Appendix 29 – Review of hazards at coastal baches

Memorandum

Subject: Review of hazard at coastal baches

This memorandum summarises our review of existing data and assessments of rockfall hazard sources that may affect coastal baches around Christchurch, specifically at Boulder Bay, Taylors Mistake, Hobson Bay and the area known as Maori Gardens near Governors Bay. The review was undertaken specifically to determine whether proposed hazard zones in these areas are justified and defensible.

Destruction caused by rockfall debris hitting rear of bach at No.63 Hobsons Bay

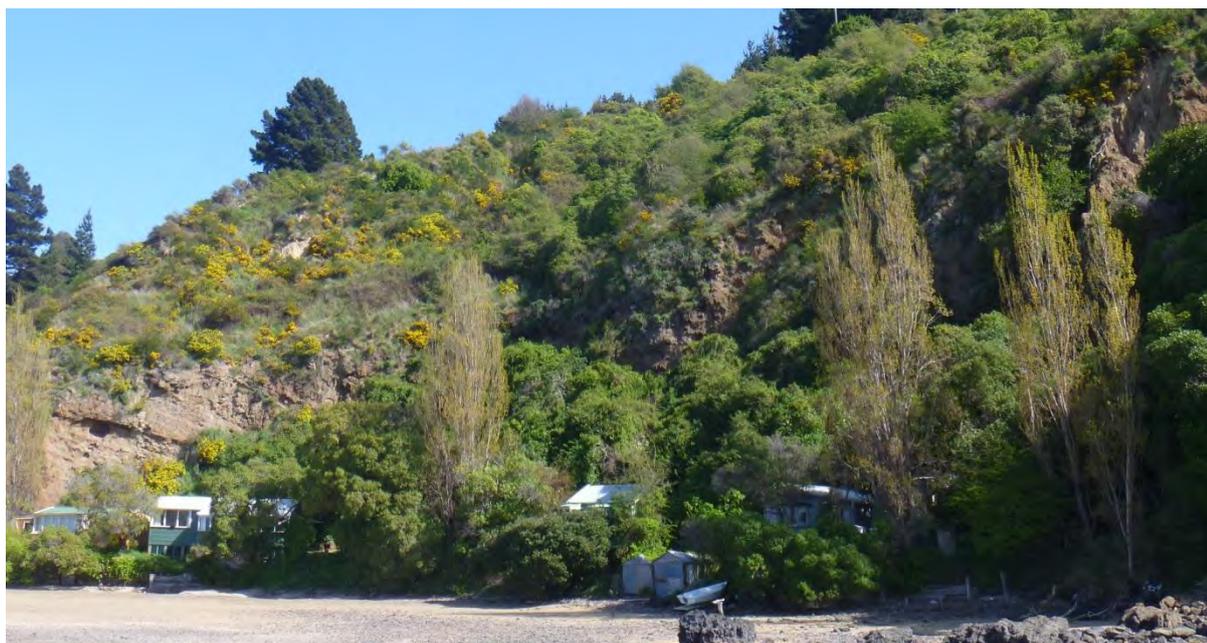
Bach No.	Assessment	Conclusion and/or Recommendation
55-58	Judged not at risk from cliff collapse. No boulder roll hazard evident.	Outside hazardous area
59	Hazard is from collapse of low loess cliff adjacent the bach that previously impacted dwelling. Has been excavated and is currently stable. No rockfall (boulder roll) hazard.	No significant current hazard
60	No hazard from cliff collapse inundation. Failure has affected slope below bach but does not undermine the structure.	Further undermining could affect stability of structure but could be remediated
62	Limited stabilisation work has been completed (shotcrete and ineffective catch fence). Building is located under a cliff which shows evidence for instability.	Site is within hazardous area. Direct cliff collapse hazard.
63, 64, 67, 68	Baches immediately under overhanging cliff which shows signs of instability, full extent of which is hidden by vegetation. Direct hazard from cliff collapse (overhanging) at all 4 sites. No.63 has been hit and badly damaged by debris that has fallen from cliff since mid 2012.	All sites within hazardous area (cliff overhangs dwelling)

Hobson Bay - Baches 55 to 59 and bach 60 should be removed from Cliff Hazard Management Area 2
